SUBJECT: Hose Reel Tilt Cylinder P/N 2130120013

RECALL NUMBER: 22V-669

SERVICE PROCEDURE FOR RECALL 22V-669

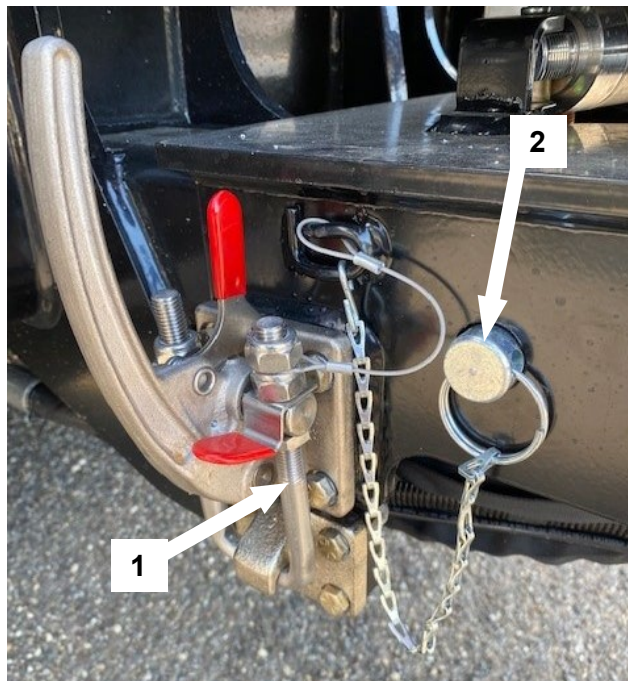
Corrective Action: The clevis on the hose reel tilt cylinder (P/N 2130120013) on the affected vehicles must be removed and replaced with an updated clevis (P/N VA0000S6257).

The original clevis (1) measures approximately 4 ¾" in overall length. The updated clevis (2) measures approximately 5 ½" in overall length and has a spacer welded between the clevis and threaded collar.
